BWROG HUMAN FACTORS ENGINEERING - CONTROL ROOM SURVEY SUPPLEMENT

In response to recently formulated regulatory requirements for design reviews of nuclear power plant control rooms (NUREG-0660, NUREG-0700), Cleveland Electric Illuminating Company has undertaken a preliminary human factors evaluation of the Perry control panels. This one week review was performed by operations and engineering personnel from three utilities, two human factors consultants, and a representative from General Electric Company. General conclusions of the survey team are as follows:

PHOTO #14

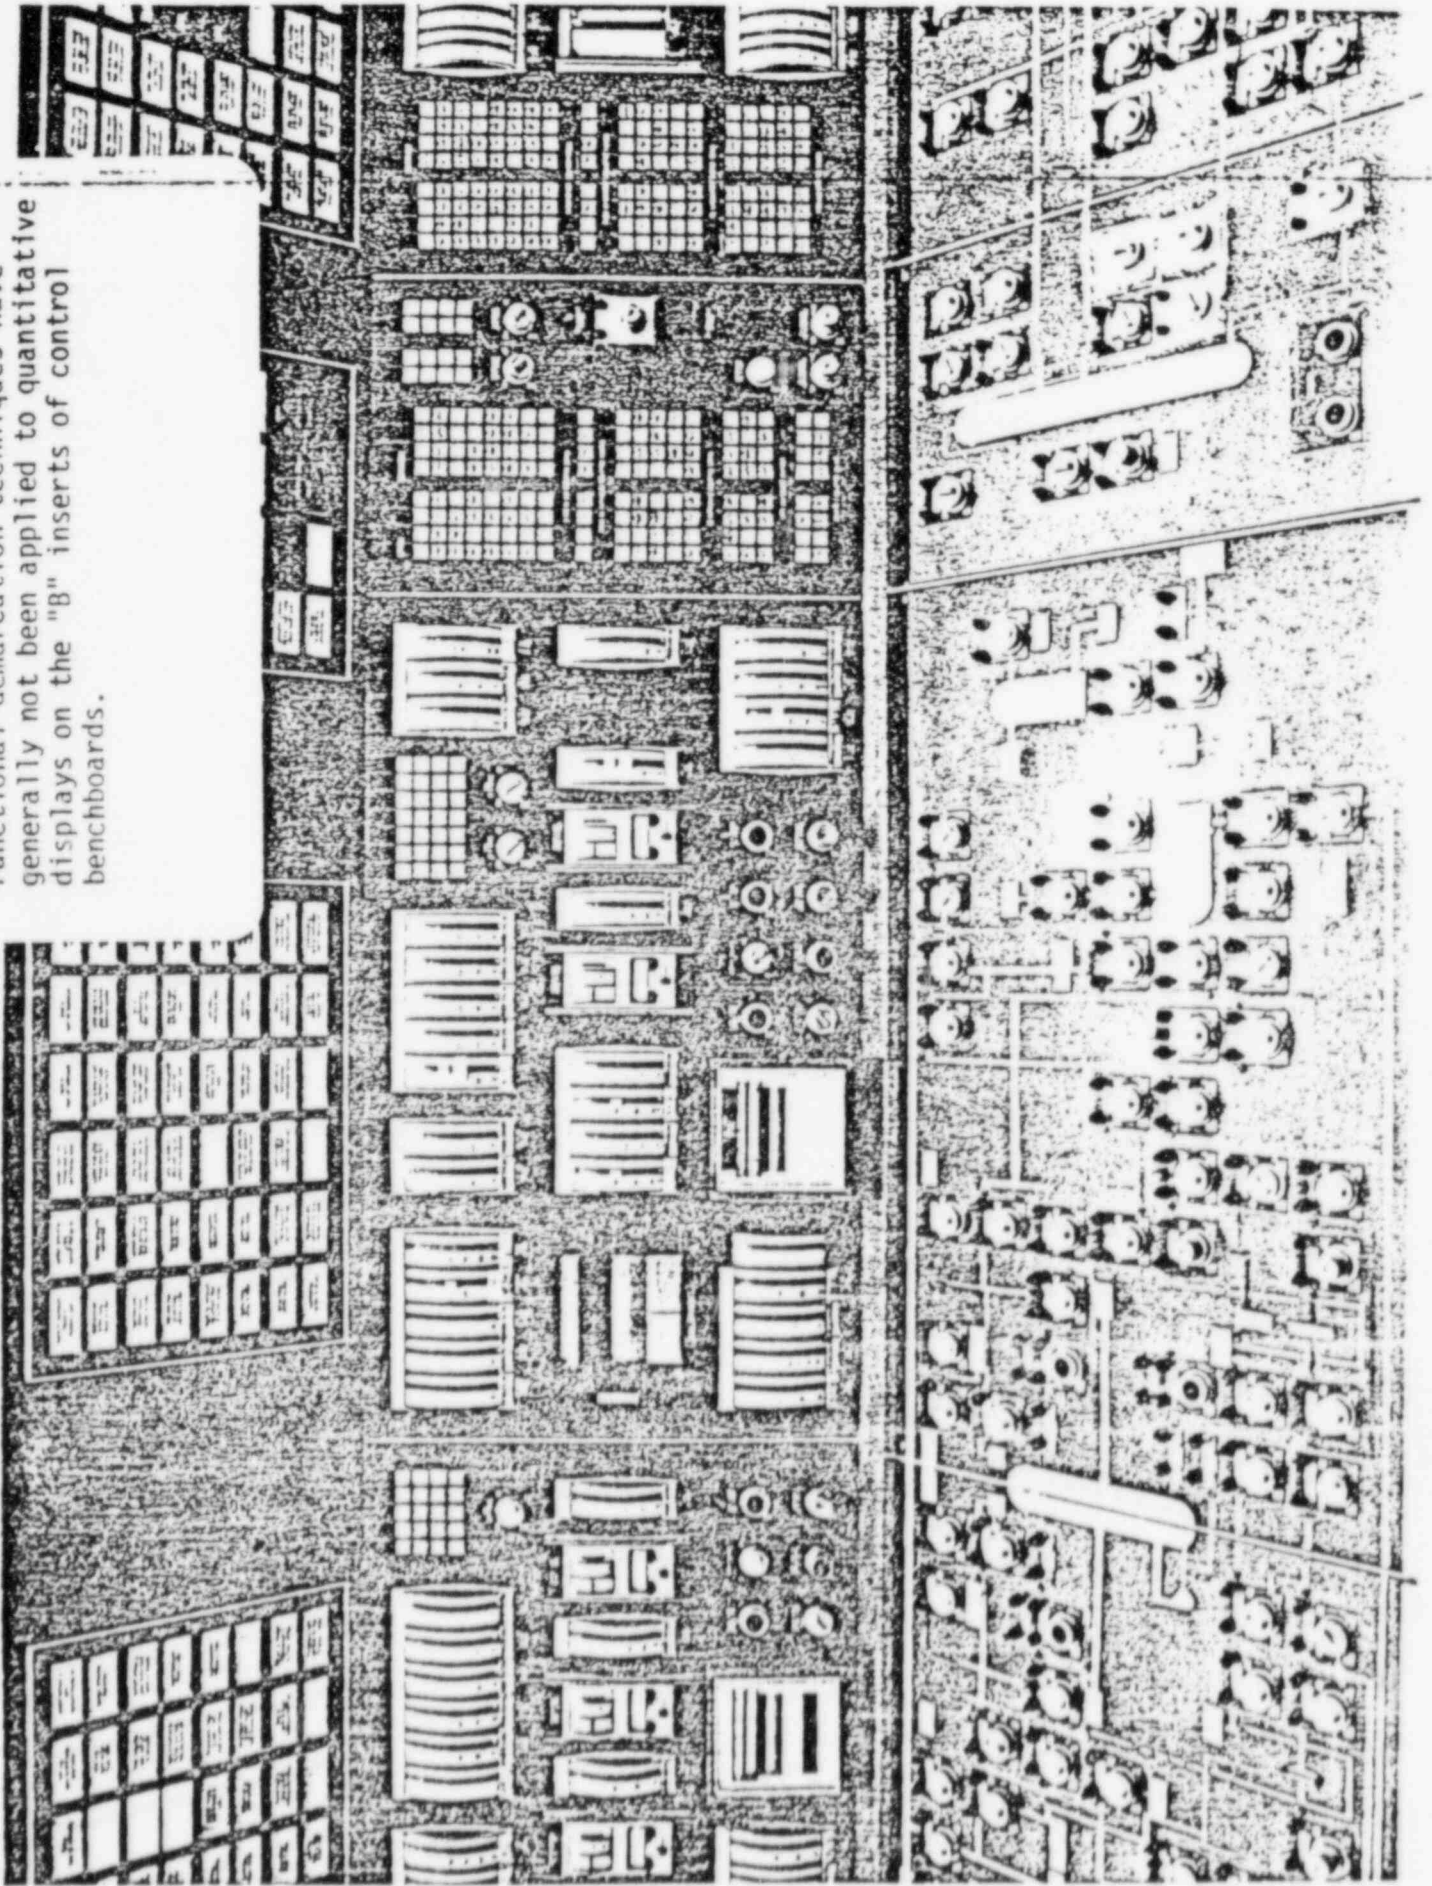
While component labels are usually very explicit, accuracy has often been obtained at the expense of succinctness. (Panel 601-21)

PHOTO #15

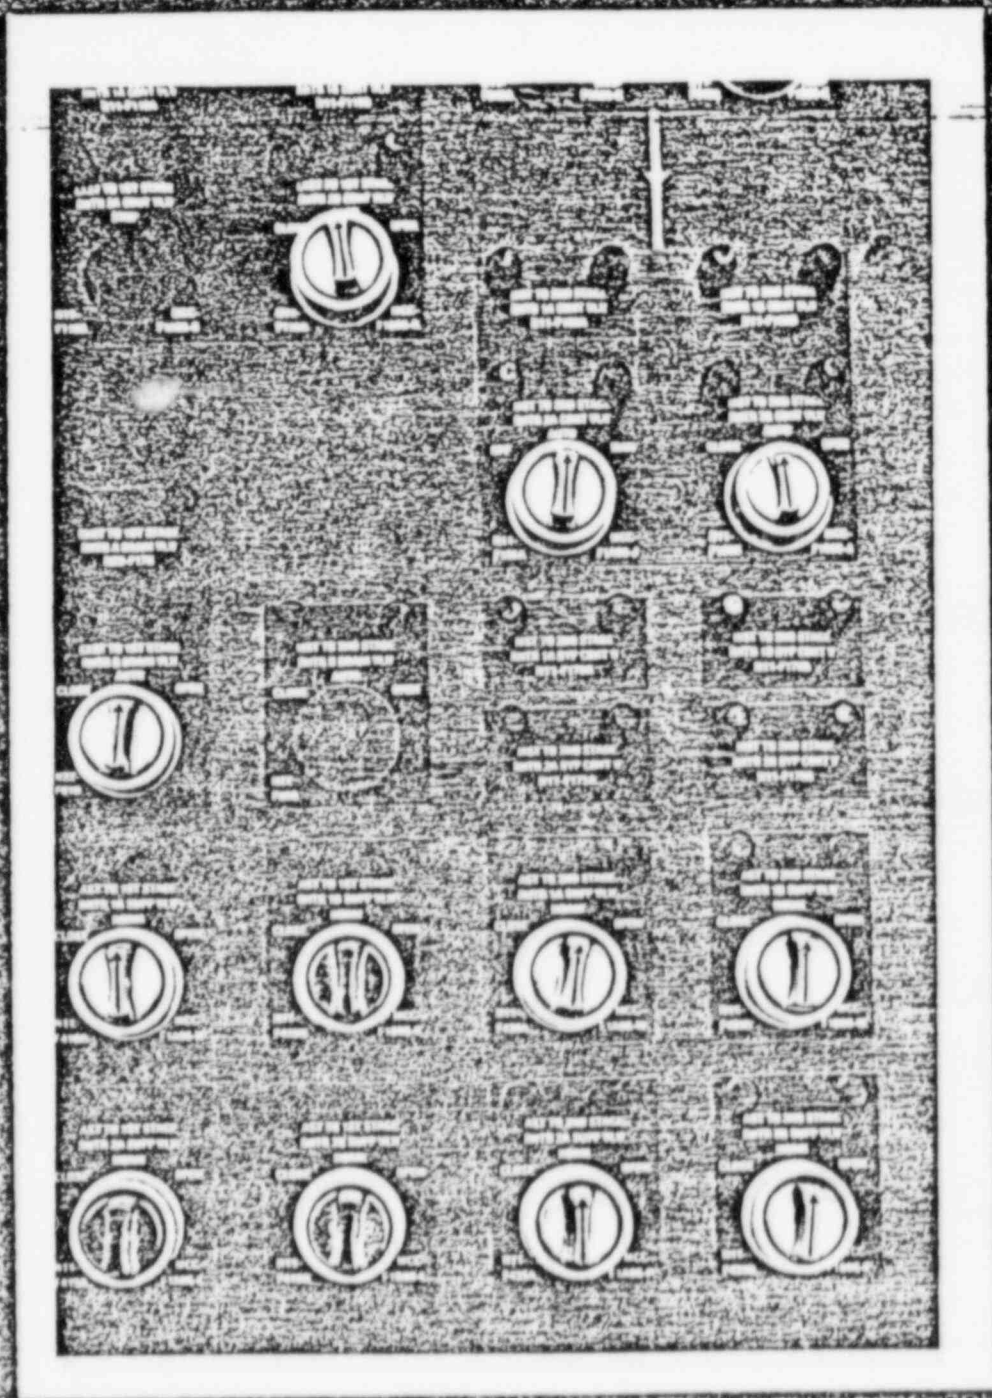
Many instances of repetitive labeling were noted. Institution of a hierarchical labeling system is recommended. (Panel 870-6)

PHOTOS #17, #18

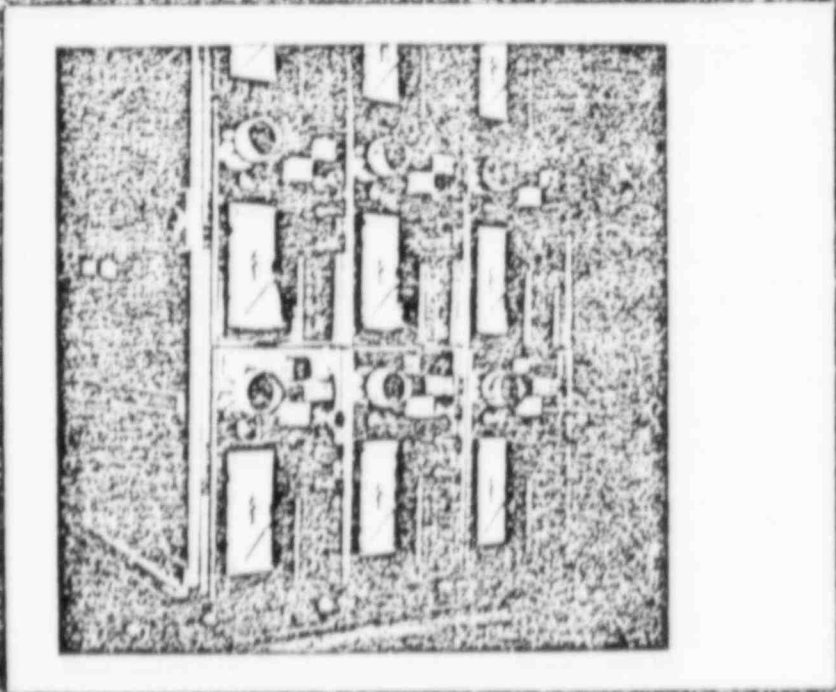
Labels below projecting vertical panel components are obscured when viewed from a standing position. (Panels 842 and 904)

PHOTO #21

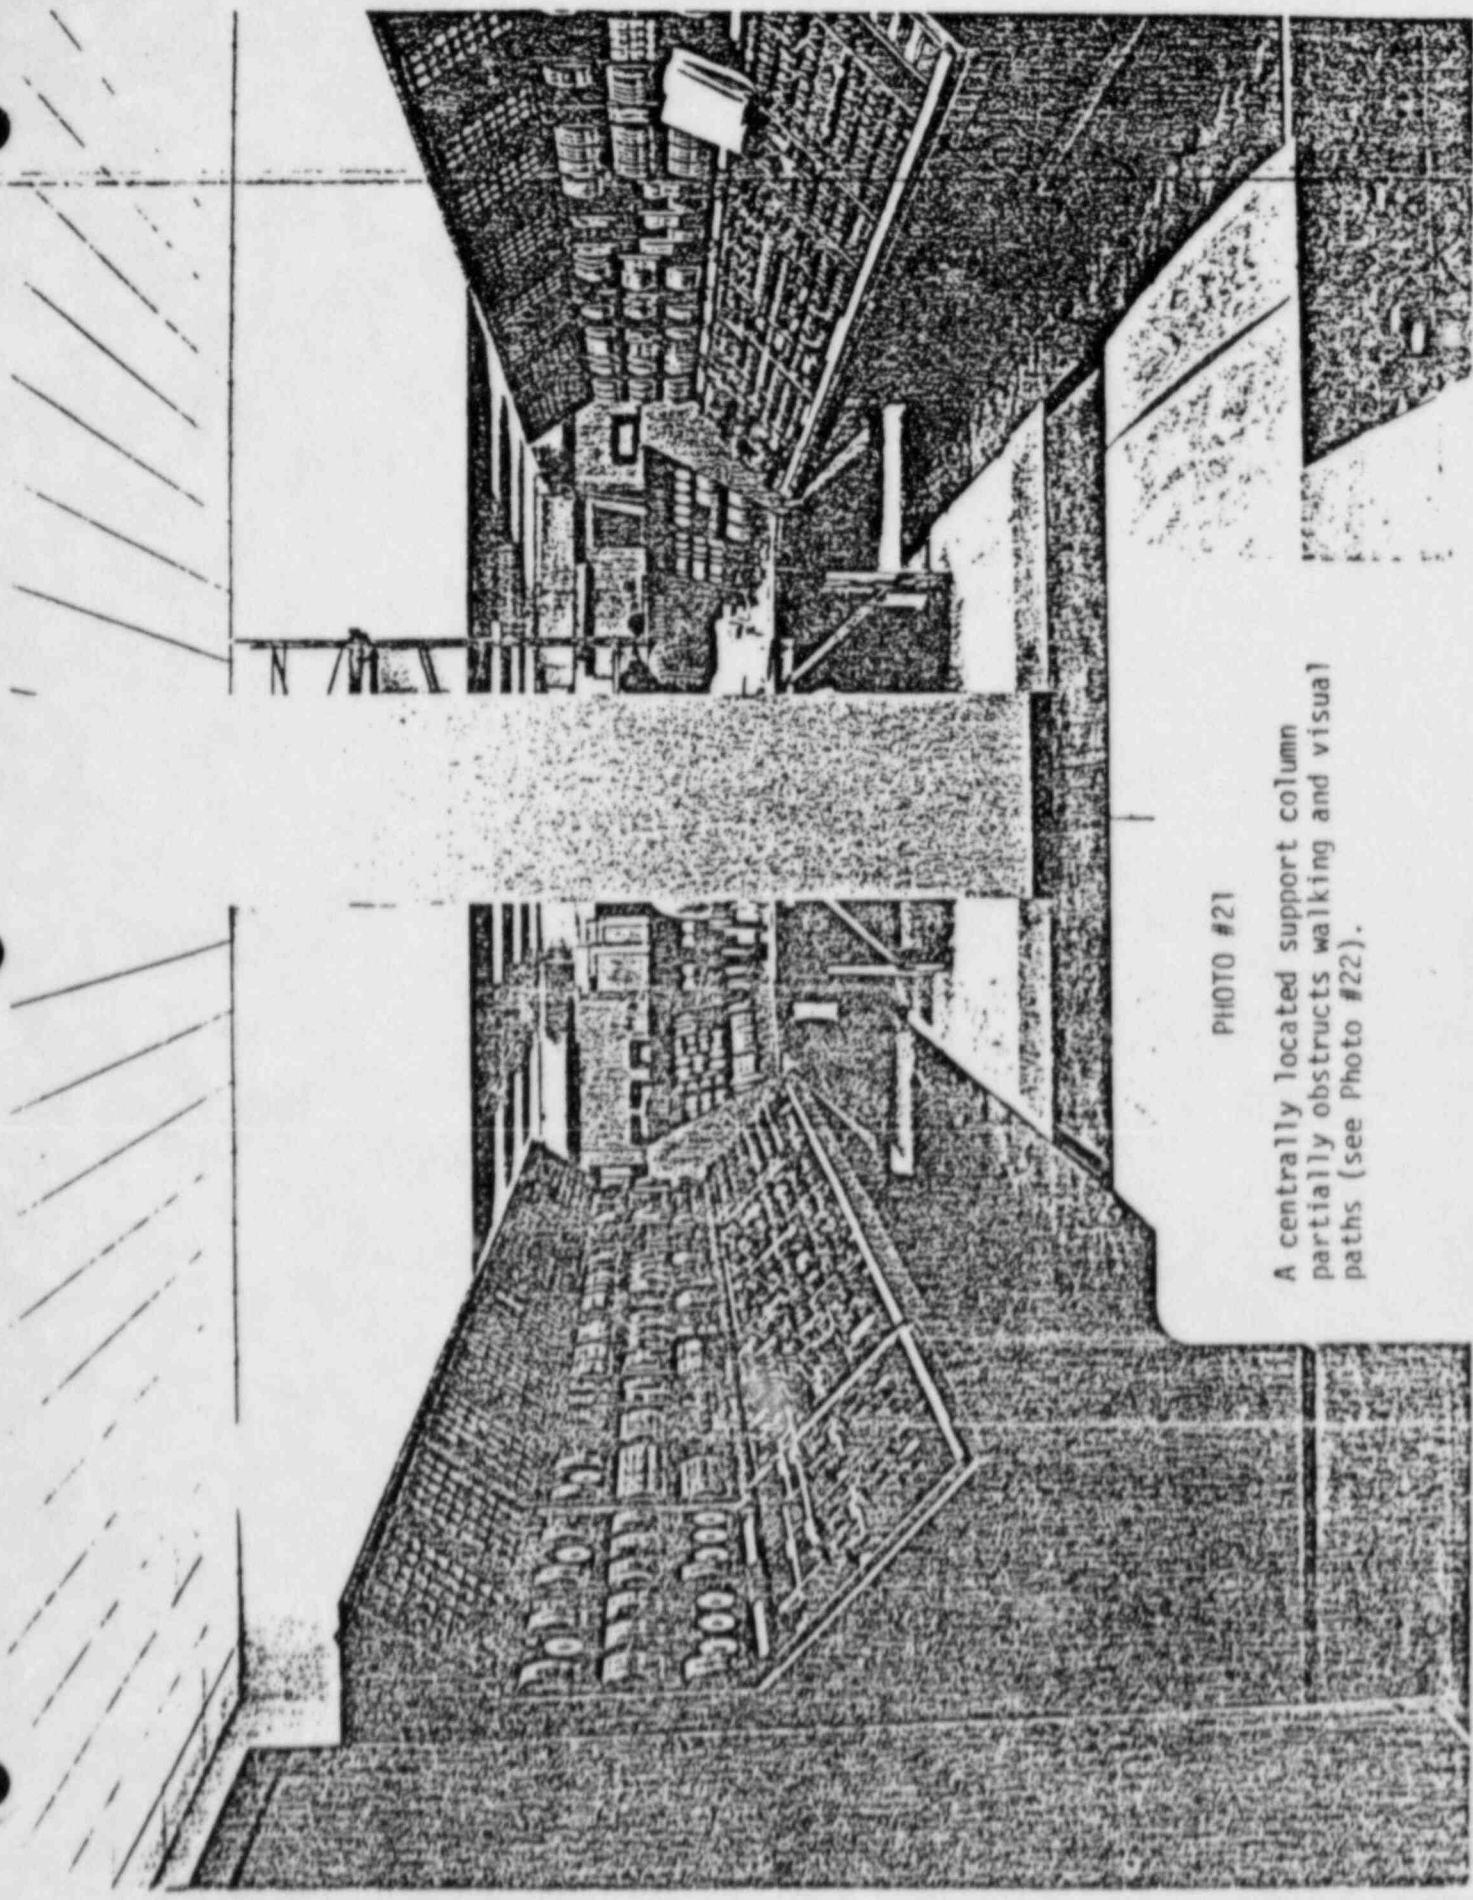
A centrally located support column partially obstructs walking and visual paths (see Photo #22).
